Council Reference: DA09/0466.02 LN71624
Your Reference: MP08_0234 MOD 3

MP08_0234 MOD 3 DA09/0466.02 – Modification to approved Concept Plan comprising residential, retirement living, retail, commercial, school and open space precincts at Lot 31 DP 850230; Conmurra Avenue BILAMBIL; Lot 1 DP 1033807 & Lot 1 DP 1033810 & Lot 1 DP 595529 & Lot 2 DP 867486 & Lot 32 DP 1085109 & Lot 33 DP 1085109 & Lot 4 DP 822786; Marana Street BILAMBIL HEIGHTS; Lot 2 DP 555026; No. 147 McAllisters Road BILAMBIL HEIGHTS

Thankyou for the opportunity to provide comment on the proposed amendments to the former “The Rise” development Major Projects approval MP08_0234 Concept Plan - Modification Application (“**MOD 3**”).

Figure 1: Updated Concept Plan Package prepared by RPS dated 10/11/2024

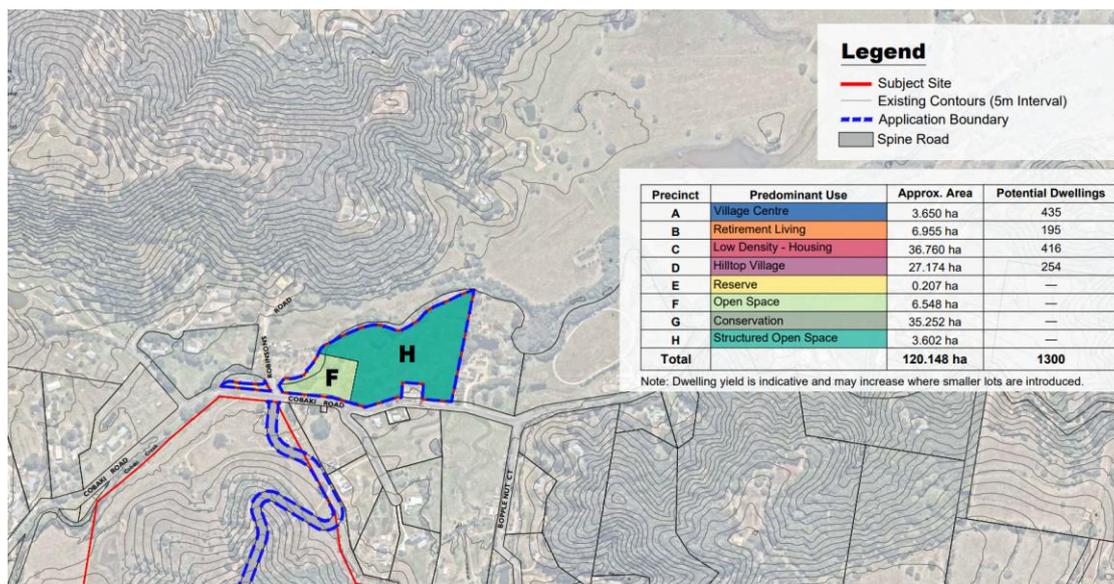
24. There is a lack of coherency amongst the submitted plans and the delivery (in terms of the quantity and quality/recreation value) of open space. To this end, it is unclear as to whether the neighborhood parks and local parks are included within the 6.548ha amount of open space indicated in the quantity shown in the table (see Figure 1 below) from the Concept Plan, given these sites are not mapped as open space and are located within the Hilltop Village and the Village Centre.

The Concept Plan Package set, specifically the pages *precinct plan* and *product summary plan* denote the letter F portions as 'open space'. Yet these lots, when viewed with the landscape masterplan are shown to be drainage and conservation lots with only one (1) of these locations being proposed as local parks. The two proposed neighbourhood parks and the third local park are contained within the 'low density' and 'hilltop village' precincts of the Concept Plan. As such, it is unclear what the provided figures for open space relate to.

26. Should DPHI be of a mind to proceed with the current modification application, despite the comments outlined in [Item 1](#) of this submission, amended plans and statement of commitments 26 is requested addressing the following:
 - a. Clearly identified and differentiated public open space, noting the accurate quantity and purpose of each on the Concept Plan for approval (e.g. recreation – park;

drainage infrastructure; conservation, etc) noting that the key "F" on the submitted Concept Plan is not indicative of usable public open space for recreation purposes (such as local, neighbourhood or district parks). By comparison, the sites nominated as embellished parks are generally not shown as open space on the Concept Plan.

Figure 2: Extract of plan nominated in the submitted Bushfire Report

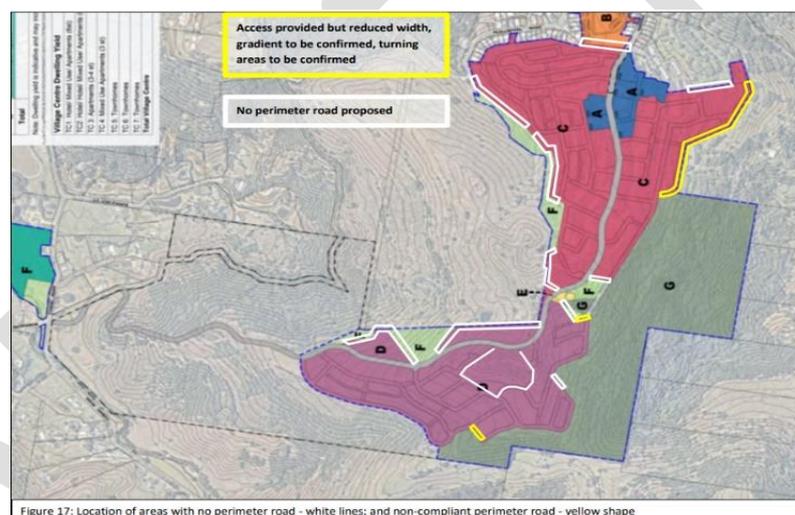
- a. Council does not accept a “no parking” area adjacent to the hazard area to the south of the site, in the location of the perimeter road. Therefore, in order for a performance solution to have merit and still satisfy Councils requirements, this road width at this location is to be increased to satisfy on street parking and required APZ's.
- b. Page 34 of the submitted Bushfire Report states that the merit for lack of perimeter road is based on these areas being generally adjacent to grassland or remnant rainforest areas requiring less fire brigade intervention to the hazard, compared to forested areas with long fire runs threatening property and occupants. See Figure 2 below.

42. The Bushfire Report considers rainforest vegetation as that nominated in the conservation area (Key “G” in the Use Plan). However, as previously mentioned, it appears that the north eastern aspect of the conservation area which is also nominated open space has not been considered as part of the bushfire report and it is unclear as to whether the subject land will contribute to a hazard and associated Asset Protection Zones (APZ) can be accommodated on adjoining residential land, noting that there is minimum buffer requirements for conservation land pursuant to Section A19 of TDCP2008 and this area lacks perimeter roads per Figure 2 above.

Figure 3: Councils preferred Reservoir arrangement

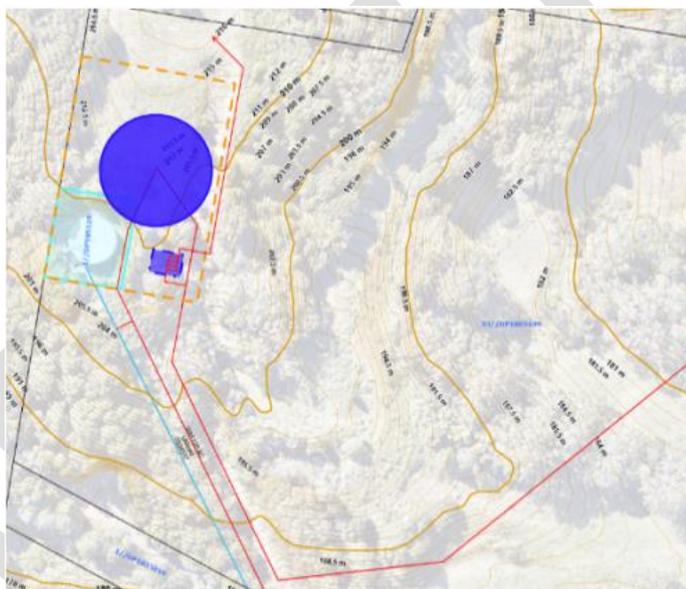
52. The applicant has proposed a combined 2766sqm site for the new reservoir inclusive of the existing reservoir. Council has assessed the reservoir requirements and has determined that the proposed land size would not be suitable. A minimum area of 52m x 75m (3900sqm, this is inclusive of the existing reservoir site) is required. This is to also allow for batters, retaining works and the new Booster Pumping Station.
53. The estimated top water level for the proposed reservoir is to be RL 213.34m AHD.
54. The proposed reservoir location within drawing 44401-WNA-752, is not a suitable location for construction of the future reservoir. Figure 3 below shows the preferred location for the new reservoir.

Figure 5: Extract of Typical Section Plan for Perimeter Road showing boulder wall

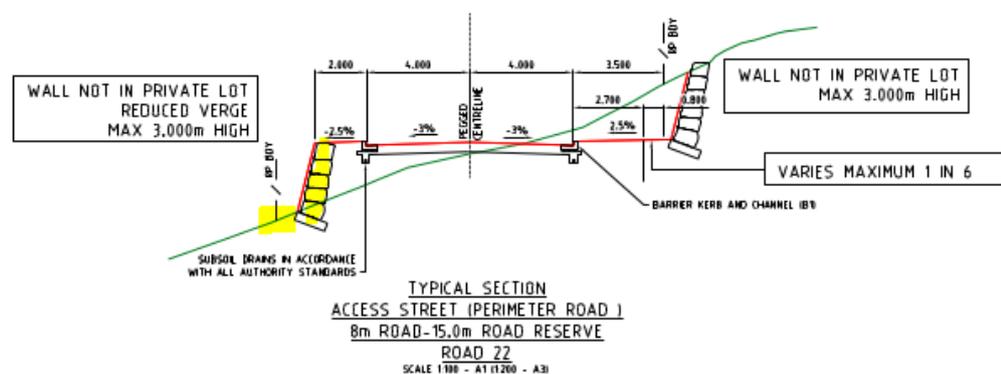
73. The provision of 6m retaining walls supporting Council's Road is a major concern and whilst Council accepts that this may be unavoidable in some parts of the site, further information and agreement needs to be entered into between the applicant and Council in relation to the design and location of such walls.
74. Council does not support large boulder walls supporting Council's Road, as shown on the Engineering Plan (extract in Figure 5 below). To this extent, Council will require safety features such as safety barriers behind the kerb and pedestrian safety fence along the top of the retaining walls where retaining walls are provided in the Council's Road Reserve. It is acknowledged that this can be dealt with at detailed design stage, however may need to form a new condition of consent.

75. The submitted documentation fails to demonstrate provision of maintenance tracks in the location of retaining walls and batters. The extent of retaining walls likely to occur across the development site compromises maintenance access points in order for Council to undertake the required maintenance of dedicated land. To this end, Council will require a minimum 3.0m wide (maximum 1:6 crossfall) service track provided at the toe of the retaining walls. This would likely require a redesign of the current design and layout for the Concept Plan and therefore should be provided as part of an amended plan.

77. It is recommended that the Concept Plan and Engineering information be amended to demonstrate that access can be provided in accordance with Item 75 above and also consider biodiversity buffers and any APZ's.
78. It is requested additional information and amended plans be provided for further consideration and comment by Council and to provide wording for updated conditions of consent where required (per TSC Engineering Design Specifications).
